Customer Satisfaction Program **24B67**

SUBJECT: Customer Satisfaction Program 24B67

Certain 2024 Model Year F-150 Full Hybrid Electric Vehicles (FHEV) and Trim Levels Lariat/XLT/XL/Pro with a 3.5L Hybrid Engine — Upper Radiator Air Deflector Repair

FIGURE 1

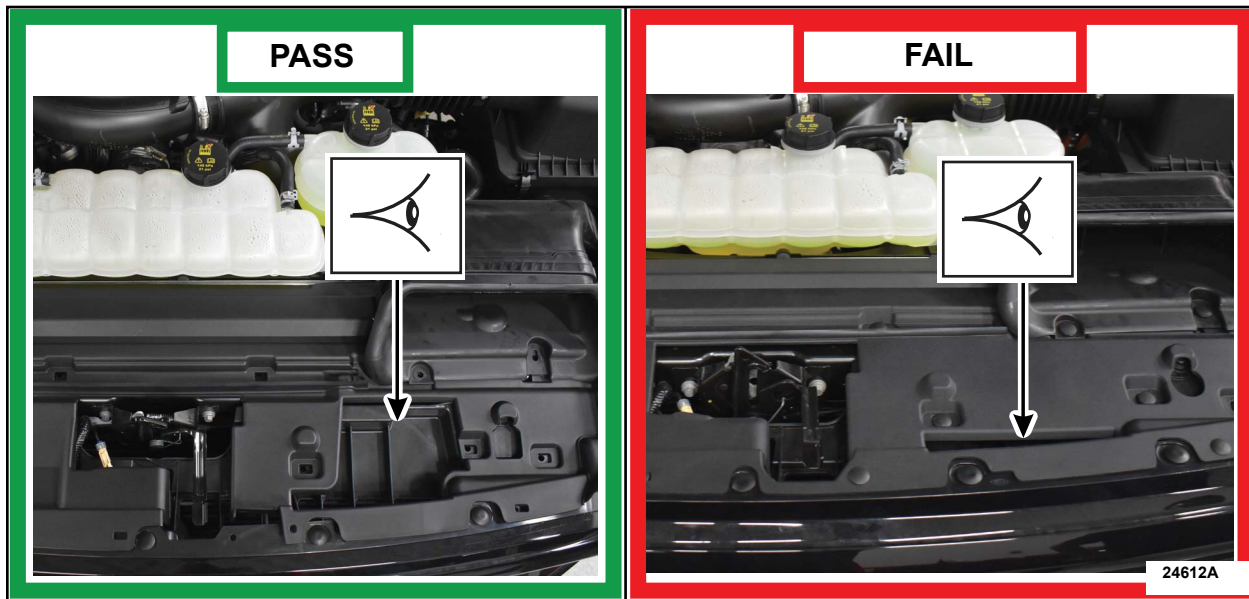
1. Visually inspect the upper radiator air deflector. Does the upper radiator air deflector vent hole Pass or Fail the inspection? See Figure 1.

Pass - This FSA does not apply.
Fail - Proceed to Step 2.

FIGURE 4

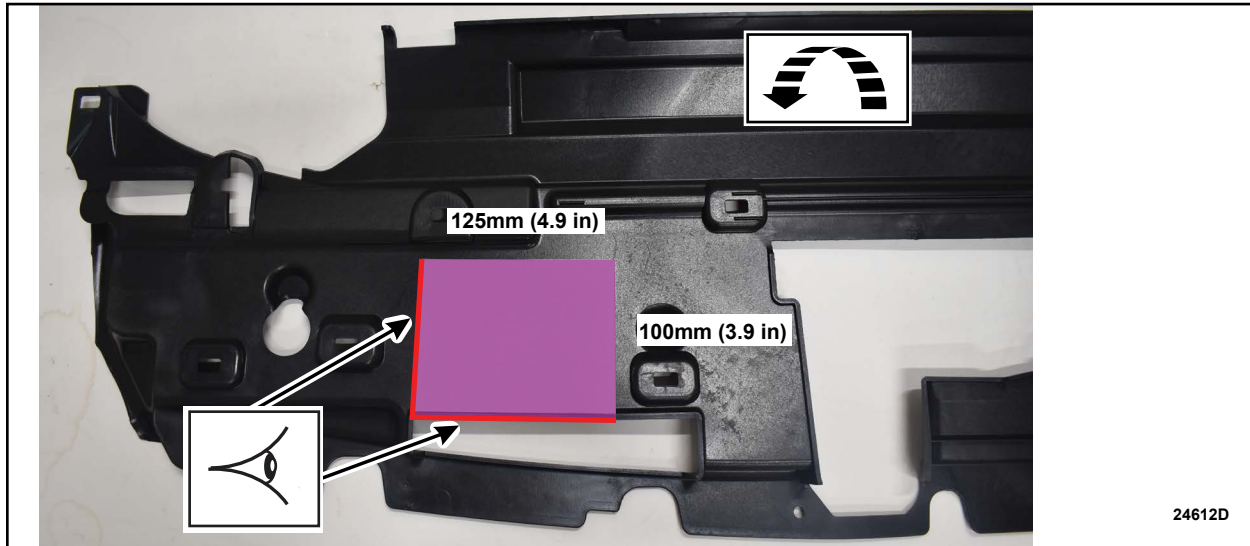
5. Turn the shield over to the **back side**. See Figure 4.

6. Use the left and bottom sides of the template to line up with the edge of the vent hole. See Figure 4.

FIGURE 5

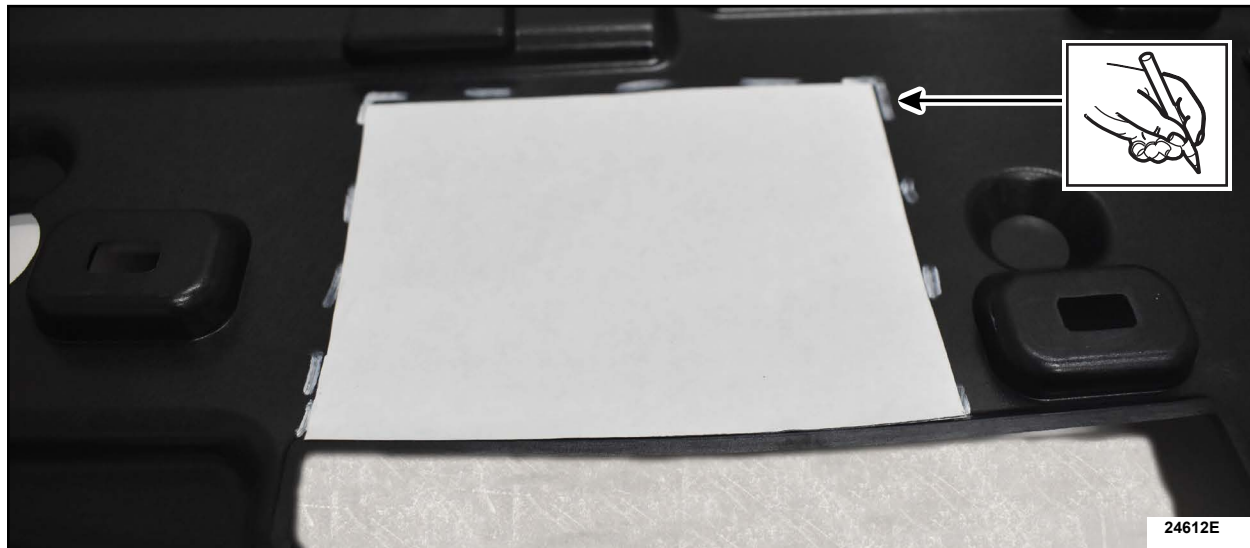
7. Trace the outline of the template onto the back side of the upper radiator air deflector. See Figure 5.

FIGURE 9

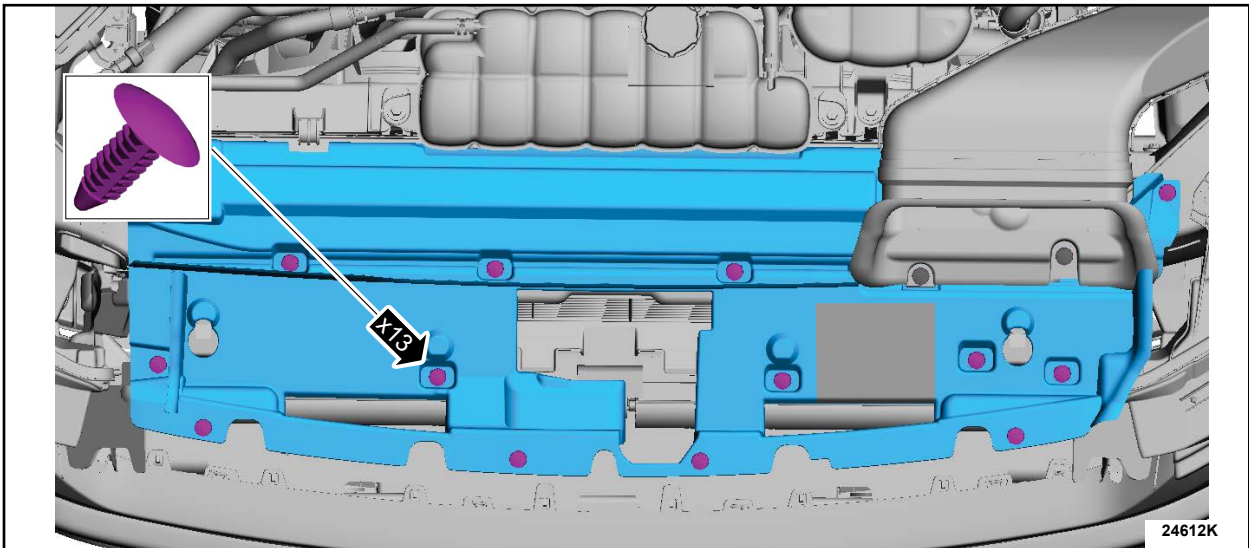
14. Using NEW push pins, install the modified upper radiator air deflector. See Figure 9.

FIGURE 11

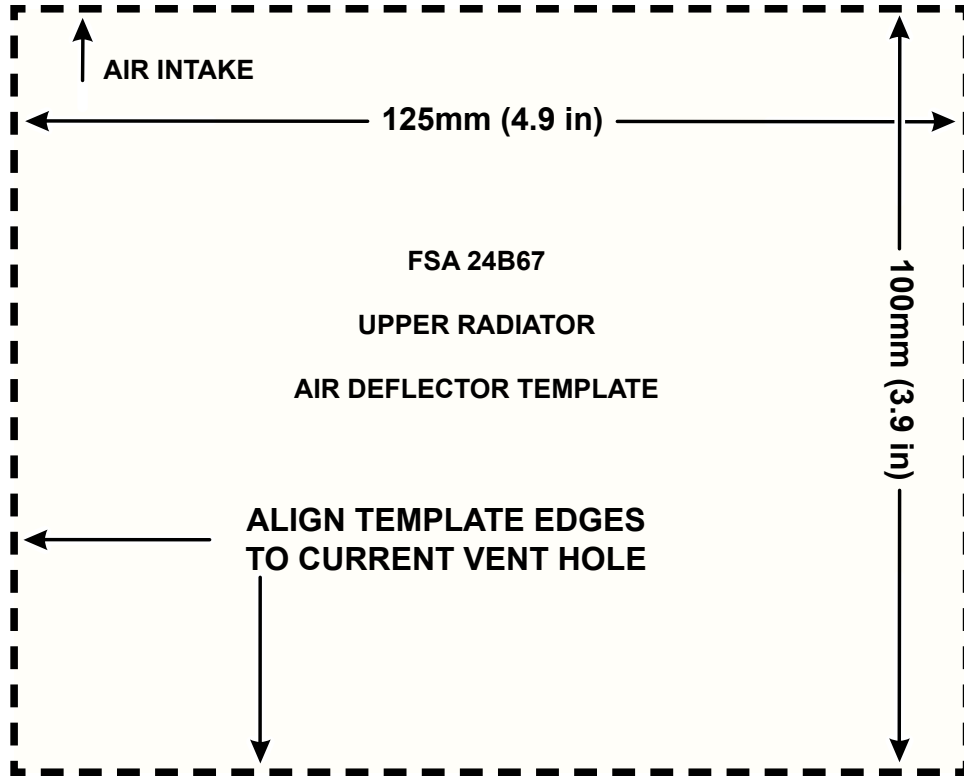
16. This Field Service Action is complete. See Figure 11.
